February 3, 2022  
Project No. 2443

Subject: **WAREHAM - Response to Peer Review Report #1 Comments  
Shell Point Place Definitive Subdivision Plan  
Great Neck Road, Wareham, MA**

Field Engineering Co., Inc. has received the initial Peer Review Report prepared by Charles L. Rowley, PE, PLS for the Town of Wareham Planning Board dated 12/6/2021 and has prepared the following responses to comments for consideration by the Planning Board.

**AS-CONSTRUCTED ROADWAY PLAN**  
**GODFREY CIRCLE**  
**CARVER, MASSACHUSETTS**

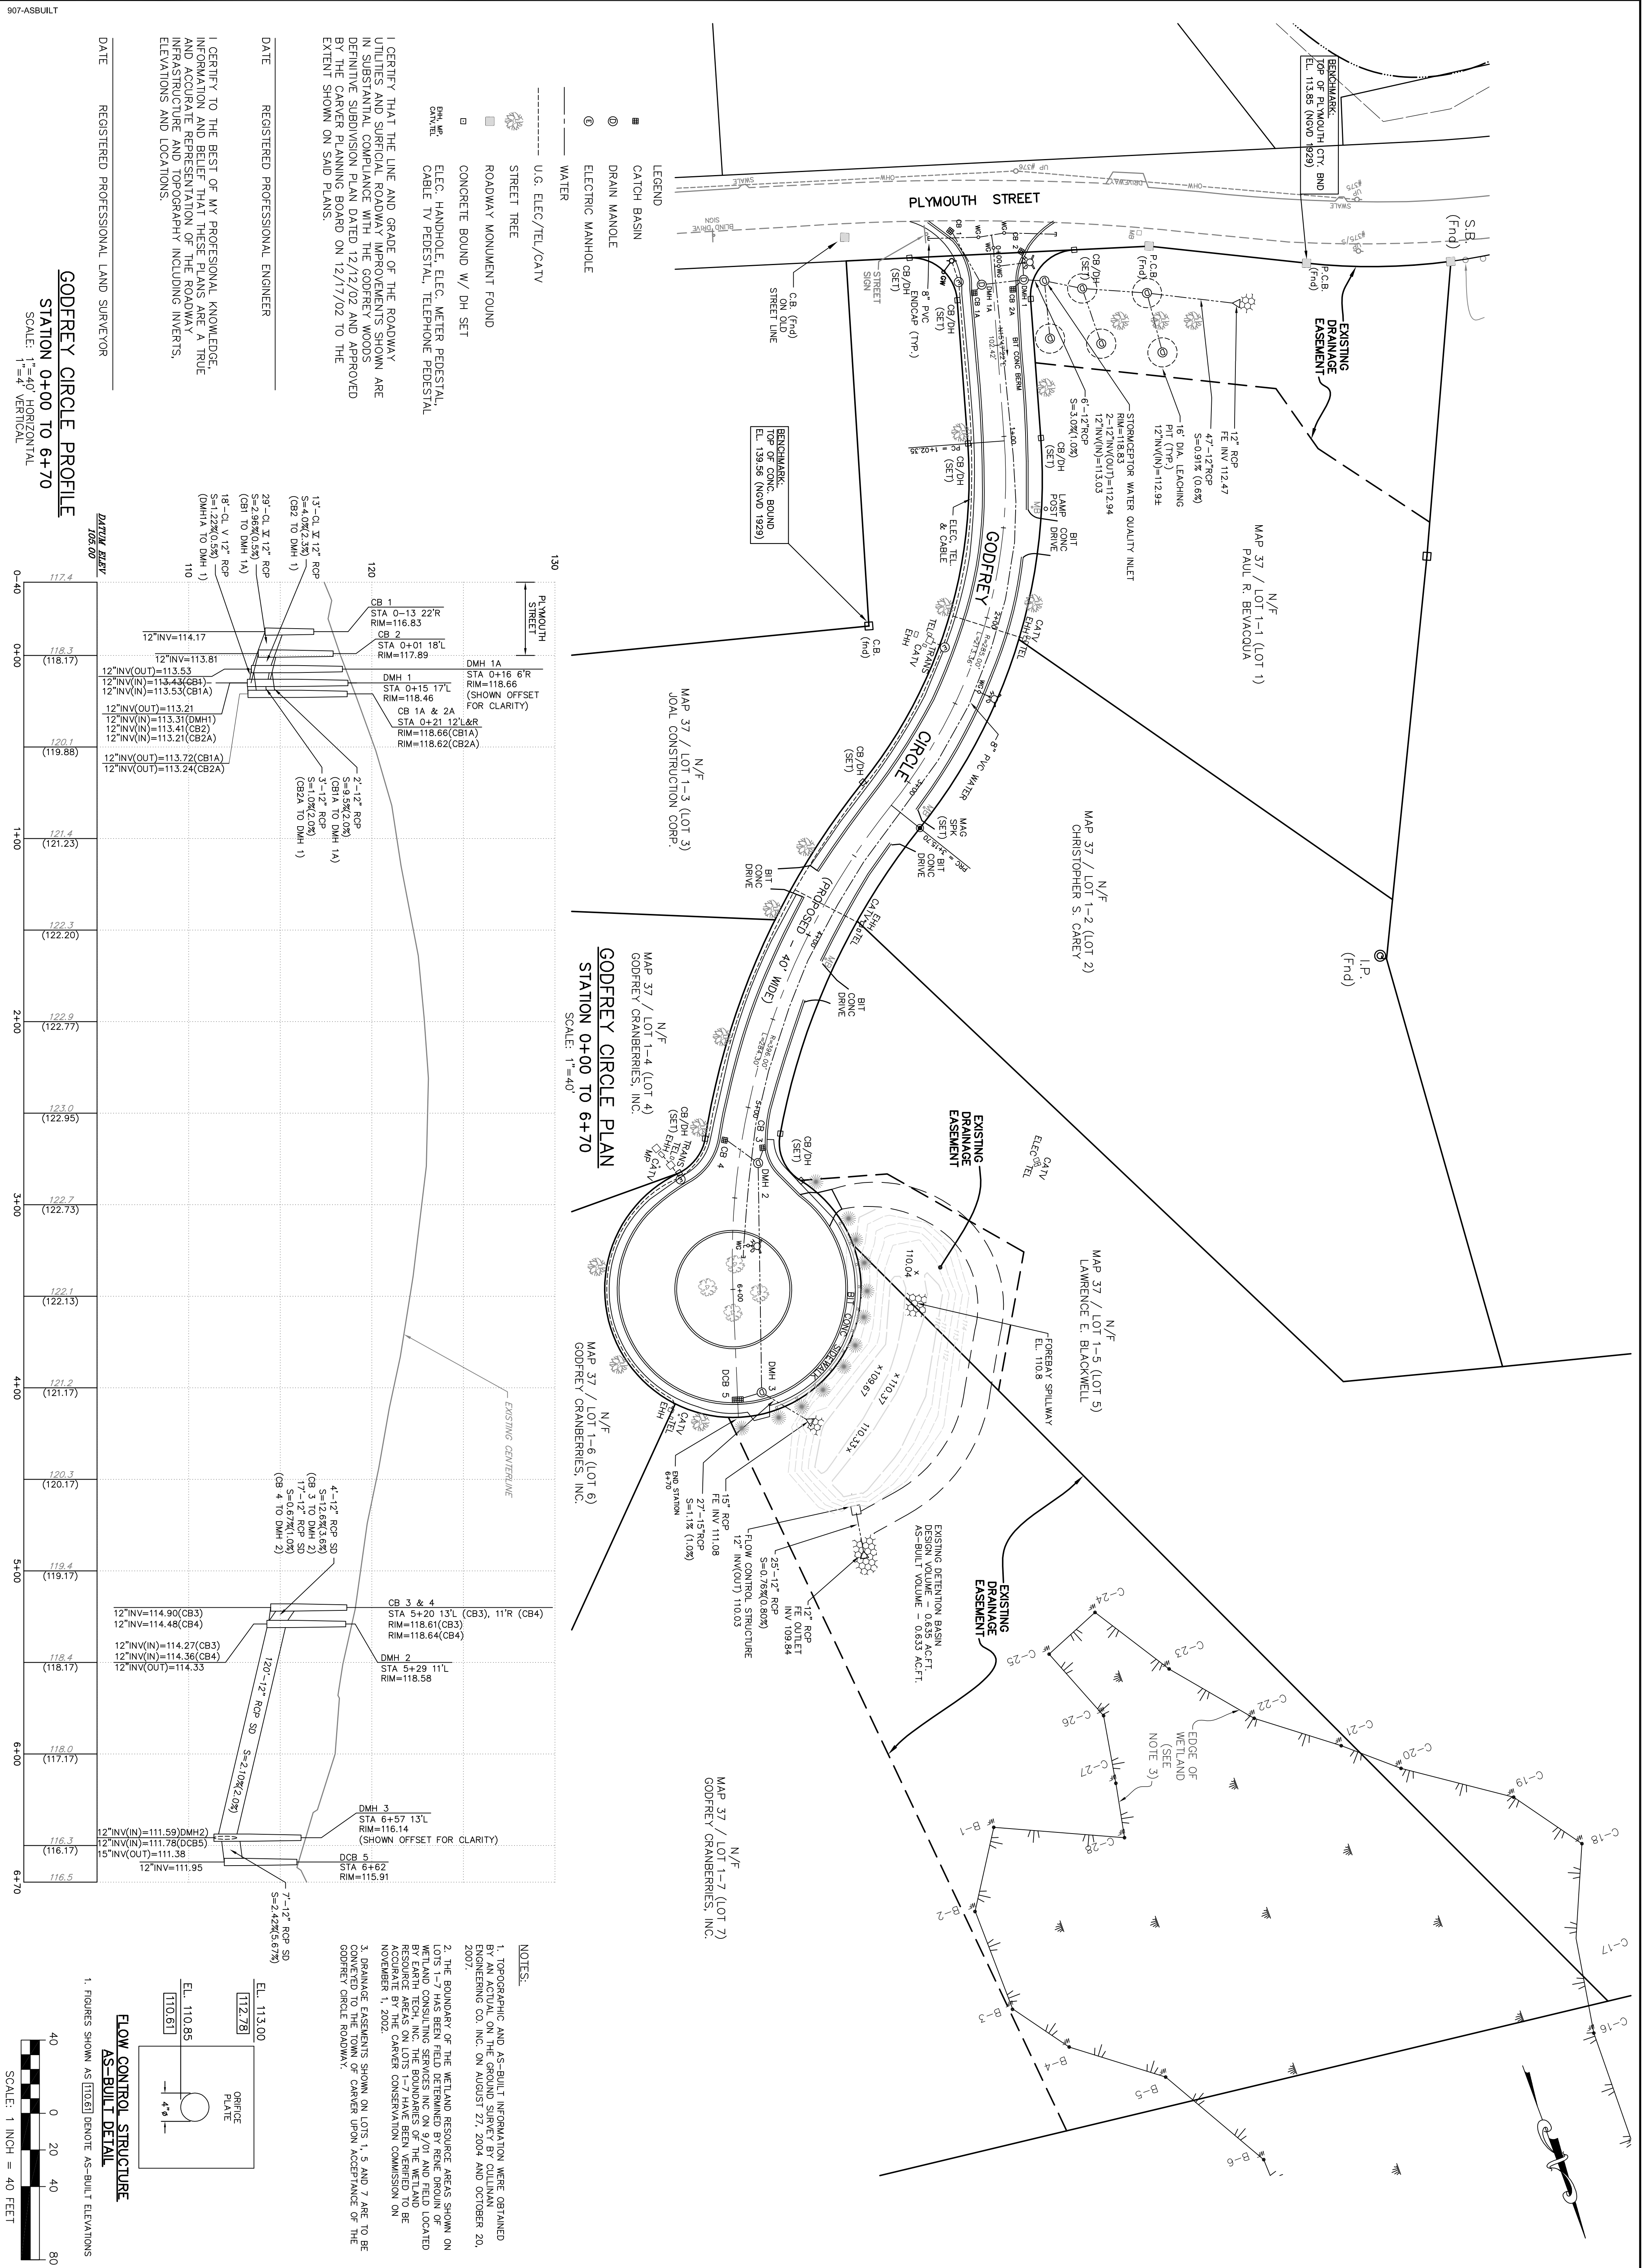
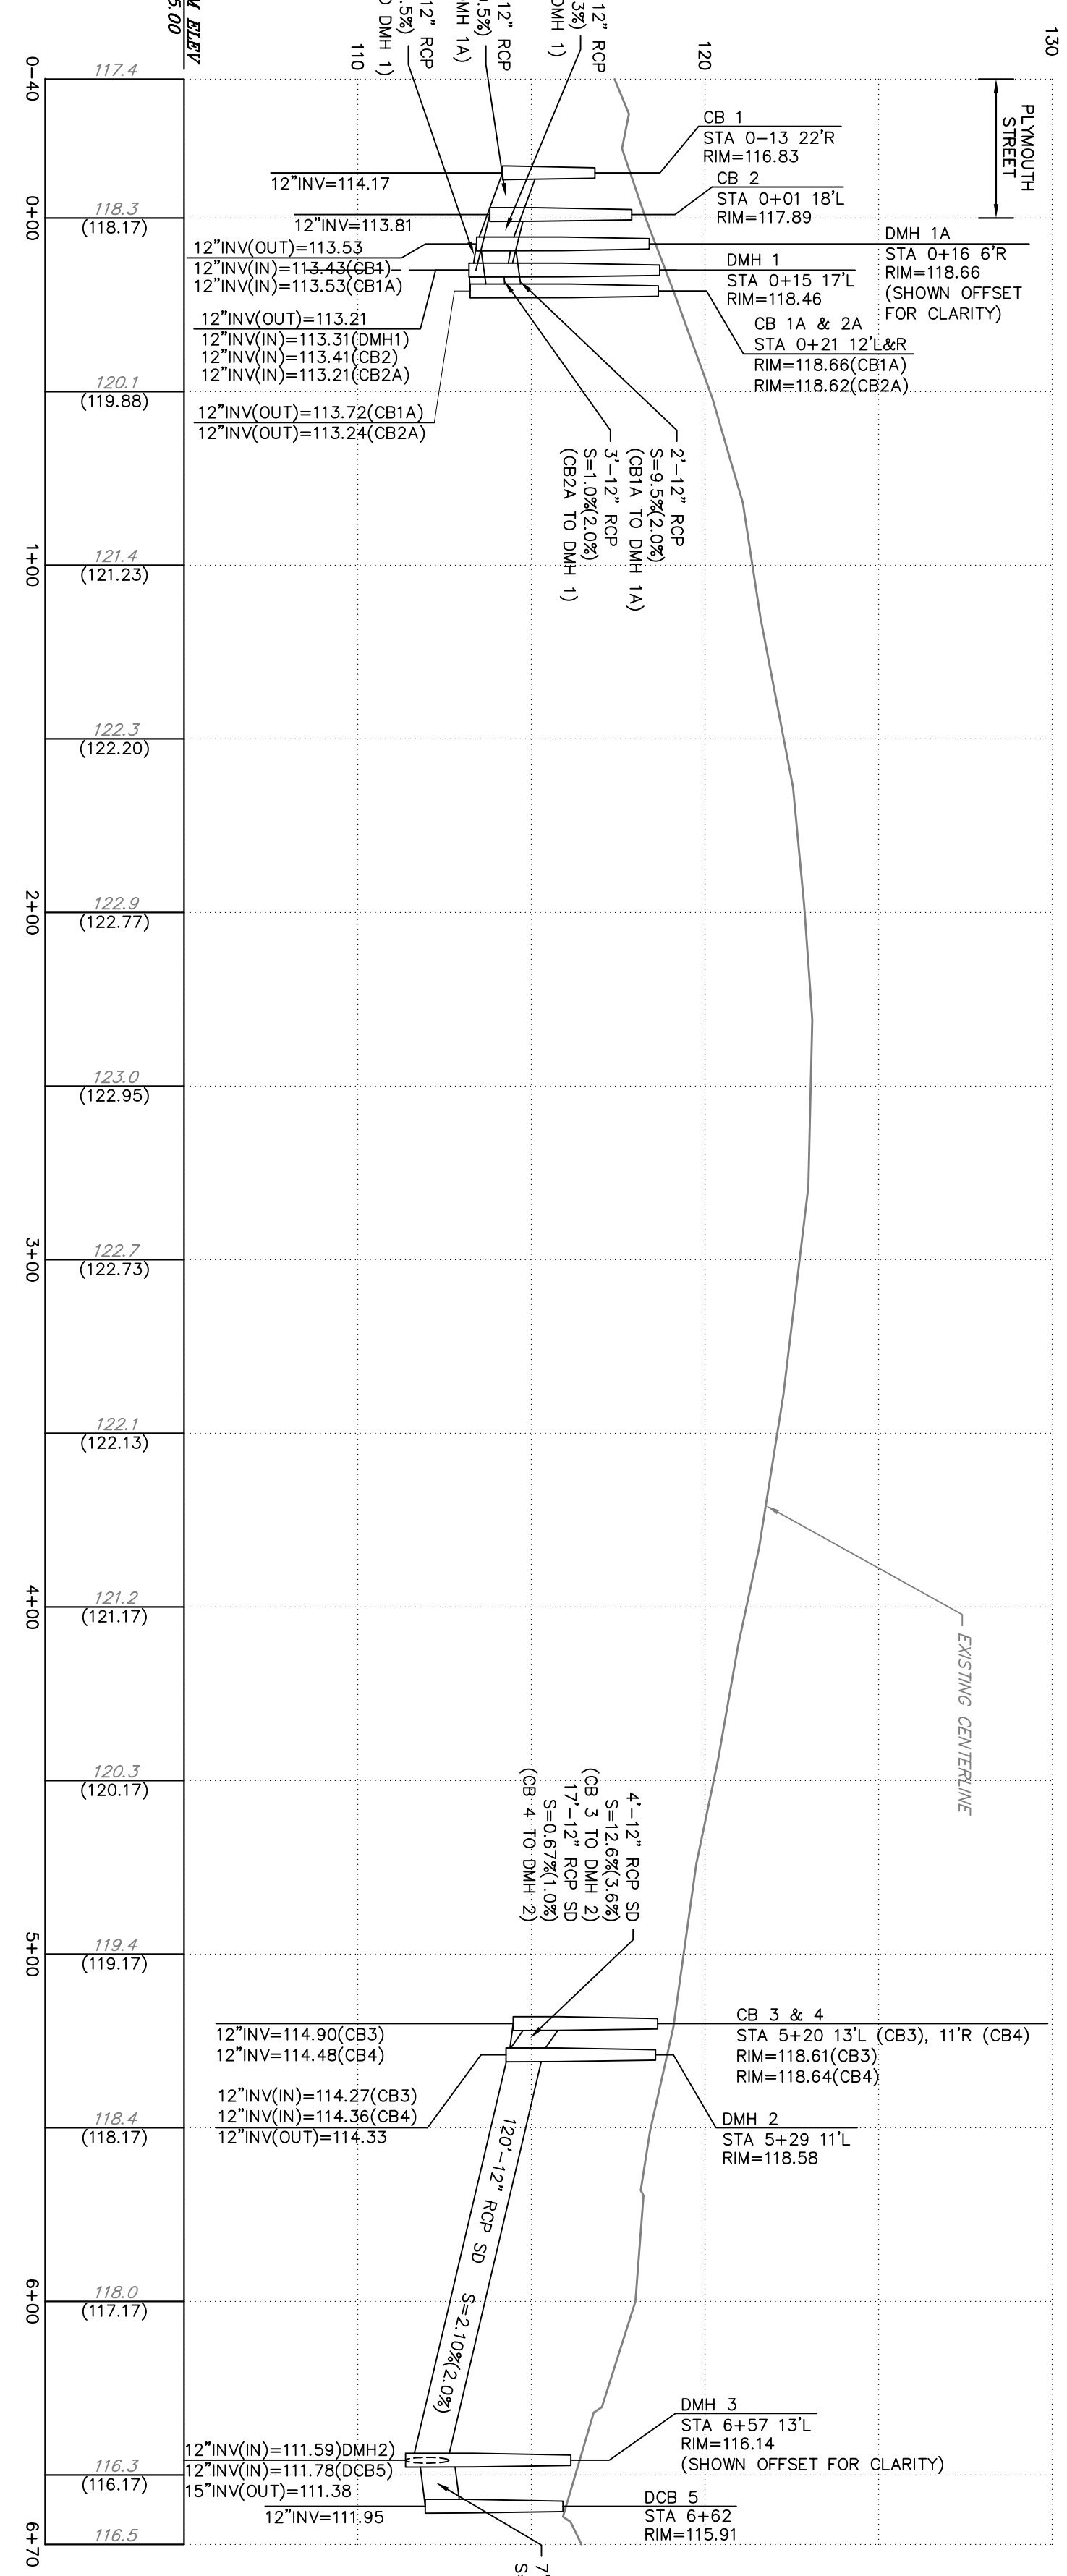
3. It is recommended that the road profile be reviewed to see if it is possible to lower the centerline grade to 2% approaching Great Neck Road rather than 4% as proposed. This would increase the grade slightly from station 0 + 40 to station 3 + 50.

4. *Field measurements and pavement observations were obtained from a similar subdivision roadway designed by our office and constructed in 2007 to assess the functionality of the roadway grading. Godfrey Circle is a 7-lot subdivision located off Plymouth Street in Carver. Profile measurements on Godfrey Circle at the intersection with Plymouth Street varied between 3.5 % and 4.5%. The profile at the centerline intersection was measured at 4.0% The transverse slope measurements on Plymouth Street at the centerline intersection was measured at 1.1%. The maximum profile change at the centerline was measured at 5.1% which is reasonably close to the proposed condition on Shell Point Place. There was no evidence of vehicular chafing or plow damage observed on the pavement*

*of either street. The As-Built Plan Godfrey Circle and photos of the intersection grade measurements and pavement are submitted in the Appendix of this report.*

Sheet No.: EX-1

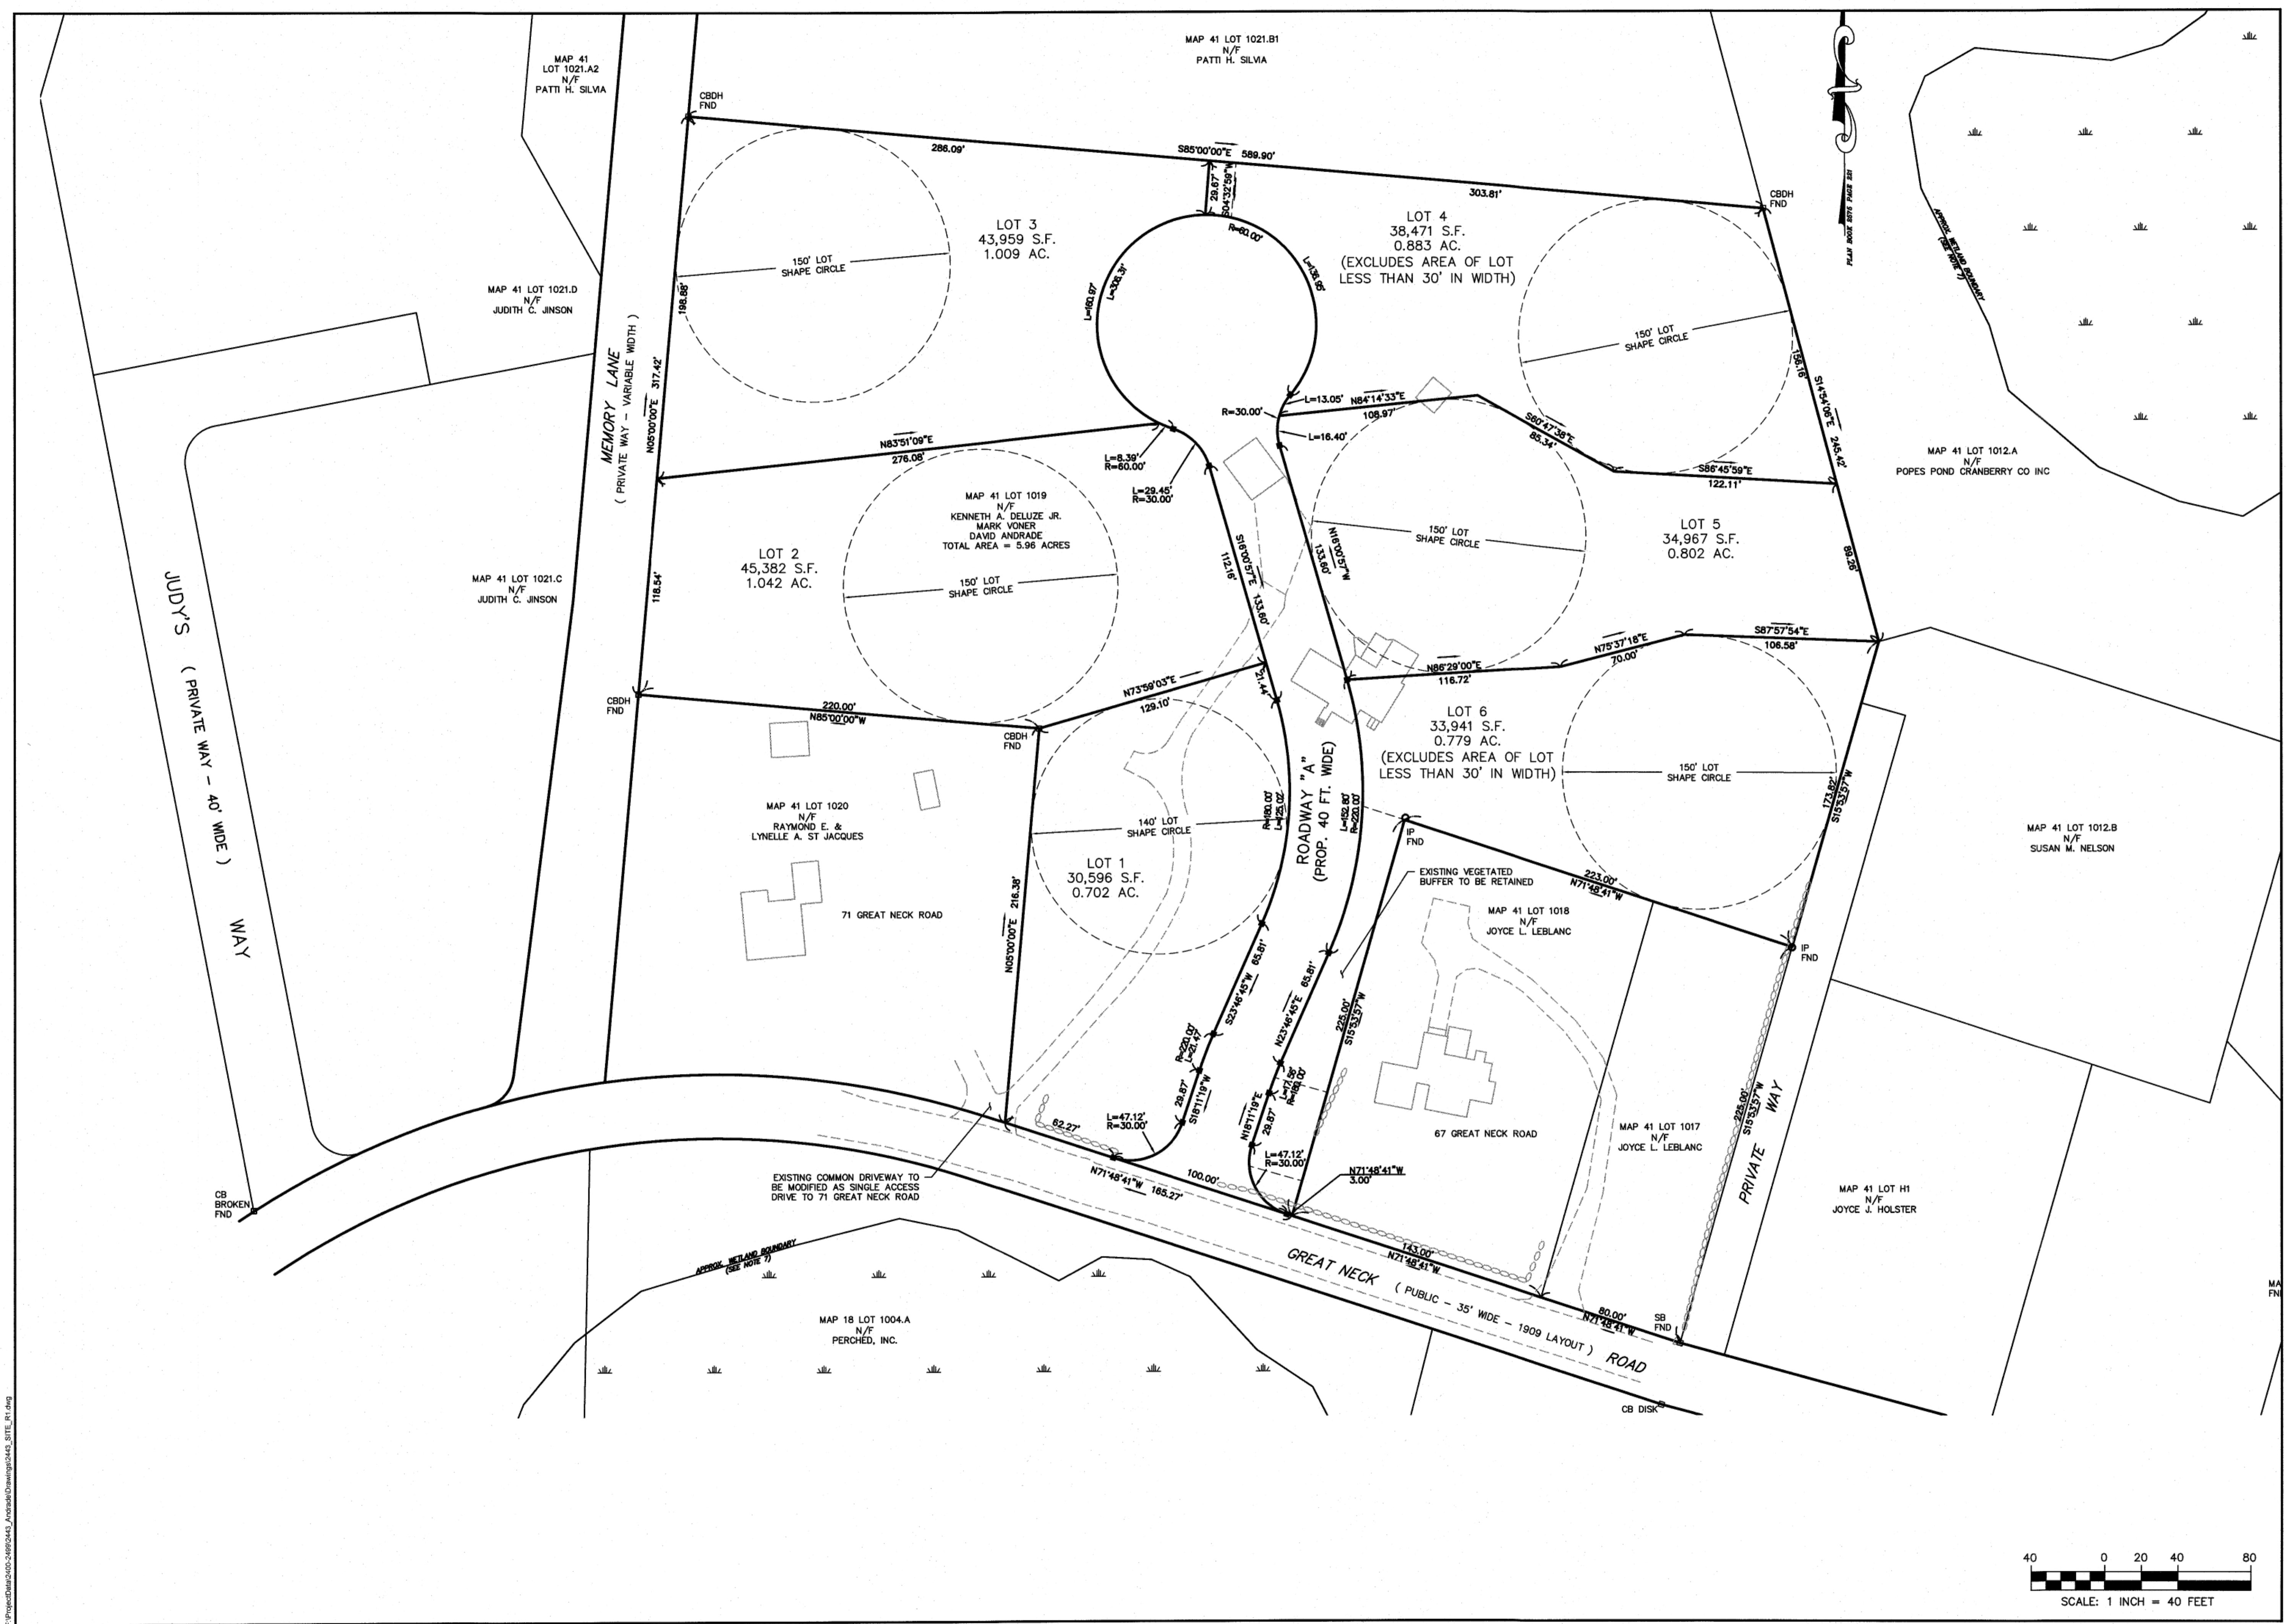
2. Section 615, Lot Shape Factor of the Zoning By-Law requires a circle of diameter equal to the minimum frontage be shown for each lot. Lots 2 and 3 of the six lots shown appear to meet this requirement. The other four lots do not.

1. Lots, 1, 4, 5, and 6 do not comply with Section 615 of the Zoning By-Law for lot shape but Section 615 gives the Board latitude to adjust the minimum dimension if it so chooses.

***FEC Response: The side lines of Lots 4, 5, and 6 have been adjusted to accommodate the 150-foot diameter Lot Shape Circle on the Exhibit Plan dated 12/14/2021. The applicant is seeking a waiver to allow a 140-foot Lot Shape Circle on Lot 1. Refer to the Amended Request for Waivers letter revision dated 12/14/2021 and submitted to the Planning Board on 12/14/2021. A copy of the Amended Request for Waivers letter is submitted in the Appendix of this Report.***

***FEC Response: The side lines of Lots 4, 5, and 6 have been adjusted to accommodate the 150-foot diameter Lot Shape Circle on the Exhibit Plan dated 12/14/2021. The applicant is seeking a waiver to allow a 140-foot Lot Shape Circle on Lot 1. Refer to the Amended Request for Waivers letter revision dated 12/14/2021 and submitted to the Planning Board on 12/14/2021. A copy of the Amended Request for Waivers letter is submitted in the Appendix of this Report.***
